# Updated Street Improvements

## Dunwoody Village Master Plan Update

8/11/2020 – As Revised following First Read

### New Roadway Improvements

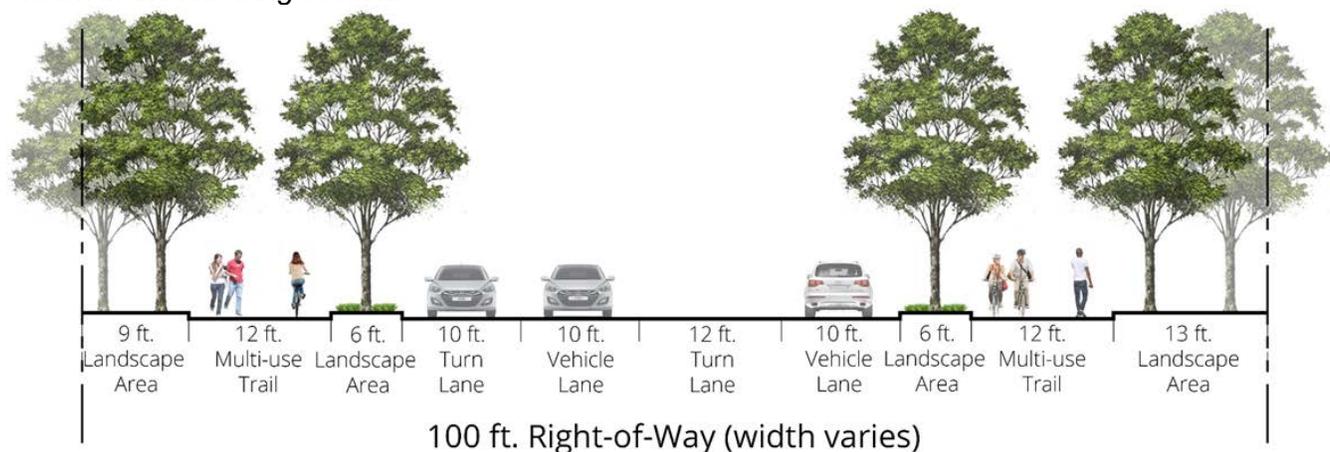
The following is appended to the end of the first paragraph on page 41:

*Additionally, the maximum speed limit should be 25 miles per hour, and mid-block crossings and intersection crosswalks should be provided when appropriate. The design of mid-block crossings and crosswalks should minimize the crossing distance for pedestrians by incorporating bulbouts, median islands, or similar features.*

### Chamblee Dunwoody Road Proposed Improvements

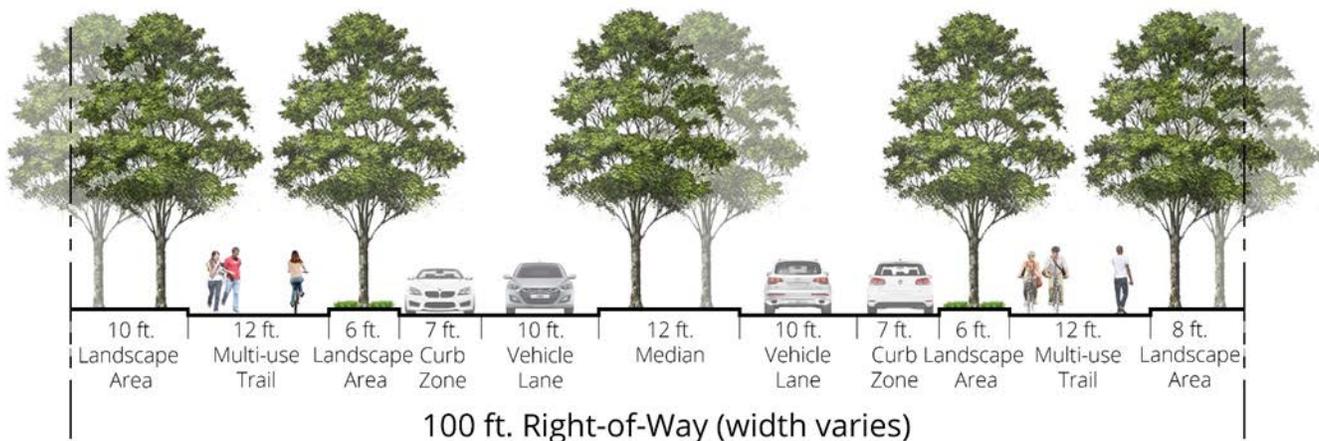
The following replaces the third column on page 43 and the first column on page 44:

*Multi-modal improvements should be undertaken for Chamblee Dunwoody Road in one or more phases. The aspirational vision for Chamblee Dunwoody Road based on typical existing right-of-way is shown in the following section:*

The above vision also assumes the following:

- A speed limit reduction to 25 miles per hour
- Street trees, pedestrian lighting, and roadway lighting
- Intersection enhancements including new mast arm traffic signals, pedestrian signals, high visibility crosswalks, and ADA Ramp improvements where necessary
- A design that minimizes the length of crosswalks to shortest distance necessary
- Removal of overhead utility lines and replace with underground utility lines
- Access management considerations to reduce and limit curb cuts and potential conflict areas along the corridor
